Reviewer #2

The manuscript "Determining the threshold of issuing flash flood warnings based on people's response process simulation" by Zhang et al. presents a novel and comprehensive approach to determining flash flood warning thresholds that considers the complexities of human response processes, which is a significant advancement over traditional methods that often focus solely on natural hydrological processes. Additionally, the study examines the uncertainties in flash flood forecasting that affect the effectiveness of warning thresholds and the role of people's tolerance for false warnings and missed events in setting these thresholds. The manuscript is generally well-written, and I have only a few suggestions for the authors to consider before it can be accepted for publication.

Figure R1. The proposed modeling framework for determining the warning threshold based on people’s response processes (the parameters in a simulation step are indicated by a rectangular box with the corresponding color background)

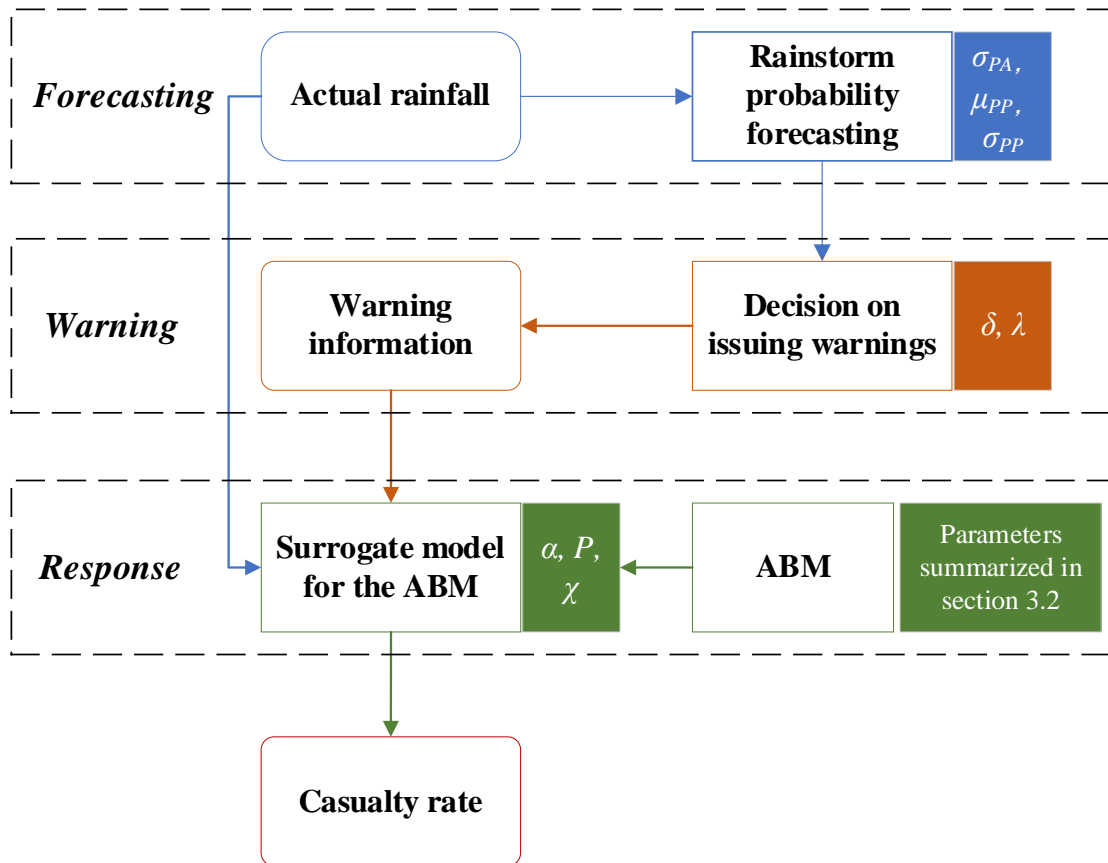
For the methodology section, I strongly recommend adding a diagram or flowchart to illustrate the relationships between the different modules and the overall simulation chain, including key variables and processes. This will be helpful for the readers to quickly understand the complex interactions and flow of information within the model.

Thank you for the constructive comment. We have added a modeling flowchart that presents the simulation chain of "forecasting – warning - response" (see **Figure R1**) in the revised manuscript for illustrating the relationship between key processes/variables. A detailed description of the figure has also been given in the revised manuscript as follows:

First, rainstorm probability forecasting is performed according to actual rainfall. And then the warning administrators make decisions to issue warnings based on the rainstorm probability forecasting and warning thresholds. If it is decided to issue warnings, the warning information and the actual rainstorm jointly drive the surrogate model of ABM to simulate the people's response processes. Finally, the casualty rate is estimated and the warning threshold that minimizes the casualty rate can be determined based on the proposed modeling framework.

Figure R2. Casualty experiment - results of Takahashi et al. (1992) experiment

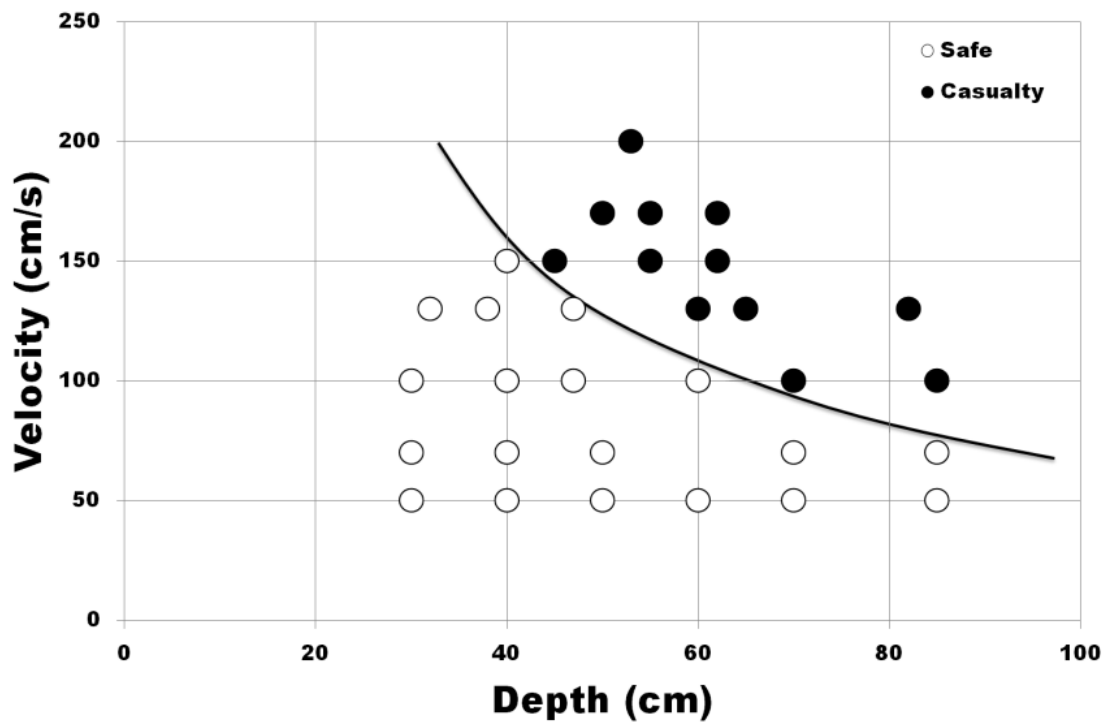
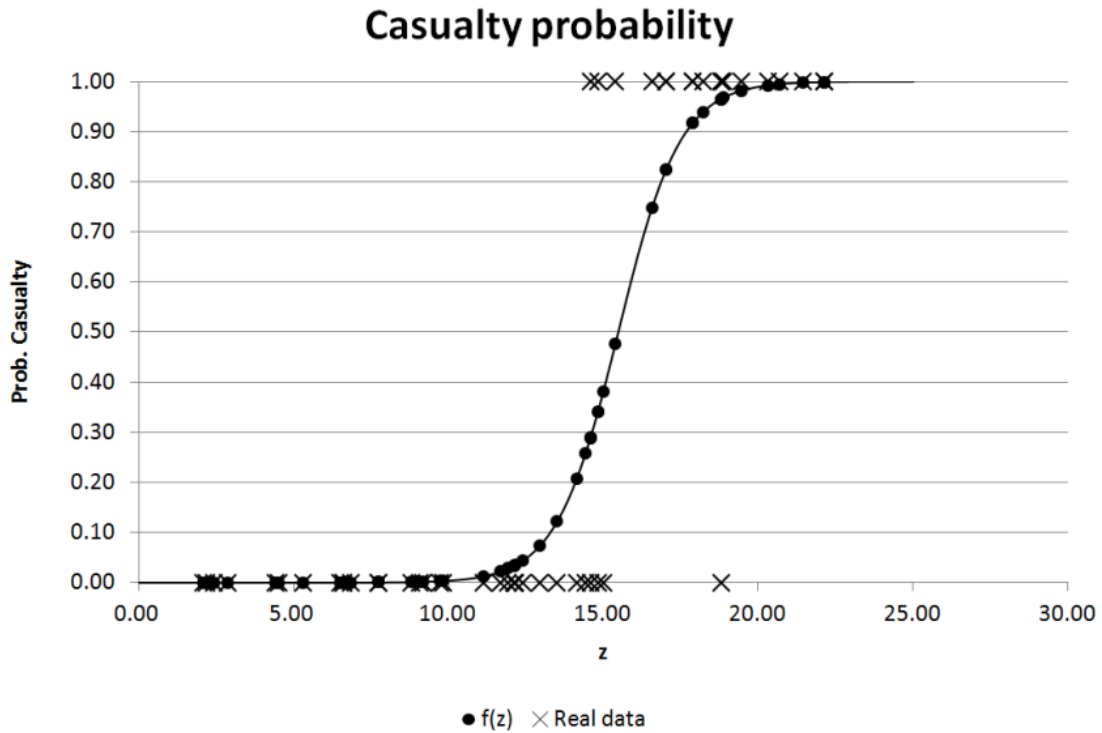
In the methods, some parameters are estimated based on author expertise and empirical data. I would suggest more information to justify the parameter settings. For example, although I assume that the parameters in section 2.1.3 are validated in the authors' previous study, at least the rationale behind the choice should be clearly articulated. In addition, it is not clear why the casualty probability is estimated using a logistic regression equation based on flood water depth and velocity. Please clarify the rationale for the choice of this particular equation.

For the casualty rate estimation module, we have added an explanation regarding the rationale for the choice of the logistic regression equation and the setting of its parameters in the revised manuscript. The detailed explanation in the revised manuscript is as follows:

*Takahashi et al. (1992) established a connection between the characterization of human stability (safe or fall) and flow features such as depth (h) and velocity (u) through a casualty experiment, and the result is shown in **Figure R2**. If variable z is set to the linear addition of h and u (i.e., $z = \beta_0 + \beta_1h + \beta_2u$), a logistic regression equation can be used to fit the relationship between the characterization of human stability (if the person falls, its value is one, otherwise it is zero) and z (see **Figure R3**). Based on the experiment data, the parameters (β_0 , β_1 , and β_2) can be estimated, and the logistic regression equation will be used to predict the probability of casualty by depth and velocity.*

Figure R4. 1,000 synthetic series of rainfall events (right). Histogram statistical results of the synthetic rainfall events. The three horizontal lines from top to bottom represent the rainfall for 1000-year return period, 100-year return period, and triggering disasters, respectively

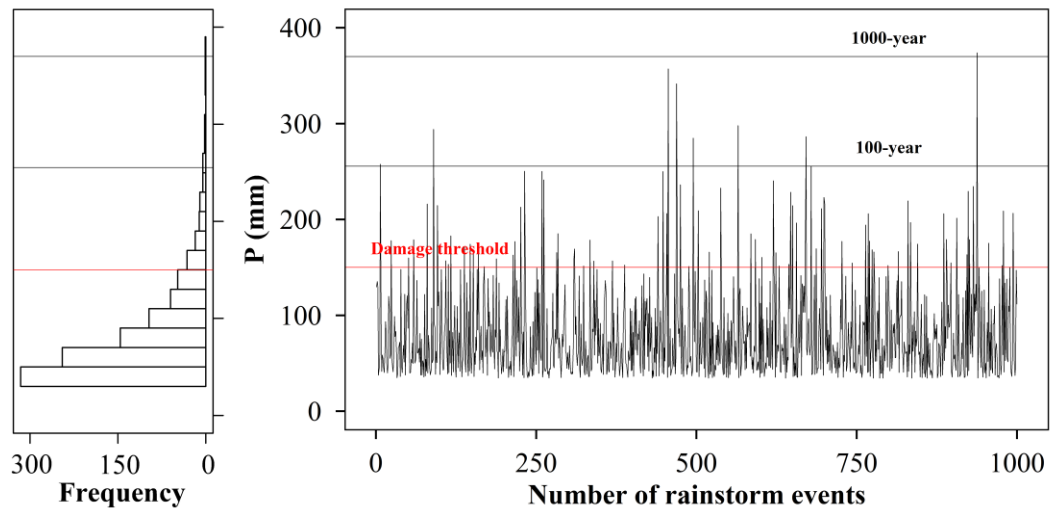
In the case study section, it is not clear what the role of event rainfall and synthetic rainfall events are in ABM. Also, if possible, please try to improve Figure 3 to make it more informative, e.g., use a histogram and indicate the level of real event rainfall in it.

The **Figure 3** in the original manuscript has been modified to include rainfall for different return periods and rainfall threshold causing disasters, as shown in **Figure R4**. The return period of rainfall in the 8.12 event (i.e., 462.6 mm) exceeds 1,000 years. And the frequency of the synthetic rainfall events was summarized through histogram plot. There is a decreasing trend of the frequency with increasing rainfall. The number of rainfall event reaching the damage threshold and exceeding the return period of 100 years and 1,000 years were only 88, nine, and one, respectively.

Figure R5. A schematic diagram that illustrates the trade-off in the warning threshold determination

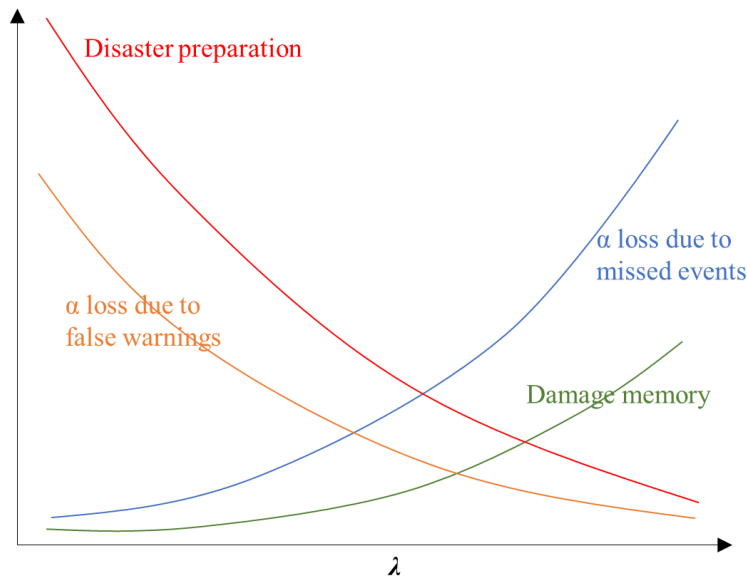
The results focus heavily on the simulation results without sufficient discussion of the implications and limitations of the results. For example, while the simulation results are detailed, there appears to be limited validation of these results against real-world data or historical flood events. Also, the results rely heavily on behavioral assumptions embedded in the ABM, such as confidence levels and evacuation intentions; I would suggest discussing the limitations of these assumptions and how they might affect the simulation results. In addition, the manuscript assumes that most parameters in the ABM are time-invariant, with the exception α . This simplification may overlook the dynamic nature of human behavior and environmental conditions. It would be beneficial to explore how varying these parameters over time might affect the model results.

Thanks for the valuable comments. We acknowledge that the discussion on the limitations and implications of the research results in the paper is weak. Thus, we have added a new section 4.4 called “implication and limitations” in the revised manuscript. In the section, the impact of time-varying parameters on the trade-off in the warning threshold determination will be discussed. Afterwards, the limitations of the

*Although the simulation results have deepened our understanding of the warning threshold determination, especially the impact of forecasting skills and people's tolerance levels of the failed warnings on the warning threshold determination, the simulation results should be carefully interpreted due to the assumptions underlying the simulation method. As highlighted in the simulation results, the warning threshold should be appropriately determined due to the trade-off between multiple factors affecting the warning threshold (see **Figure R5**). Specifically, as the warning threshold increases, the number of missed events and the loss of α due to missed events will increase. And as the missed events increase, the level of disaster preparedness will decrease. The loss of α and the low level of disaster preparedness are not conducive to reducing disaster damage. However, as the warning threshold increases, the number of false warnings and the loss of α due to false warnings will decrease, which is conducive to reducing disaster damage. Therefore, there is a trade-off in the warning threshold determination. However, it has been assumed that the experience of warnings (i.e., the success or failure of past warnings) only affects people's trust levels in warnings (i.e., α). Actually, the experience of warnings can also affect people's attitudes and behaviors towards flash floods. Specifically, the dangerous experiences on the property/life losses can form deep flash flood memories. The damage memories make people more inclined to evacuate after receiving warnings (Cuite et al., 2017; Morss et al., 2018). The higher the warning threshold, the more missed events and dangerous experiences there will be, and people's damage memories will be more profound. The profound damage memories increase people's evacuation intention and reducing disaster damage. Therefore, if combined with the dynamism of human behaviors, there still be a trade-off of the warning threshold determination but the optimal warning threshold will increase.*
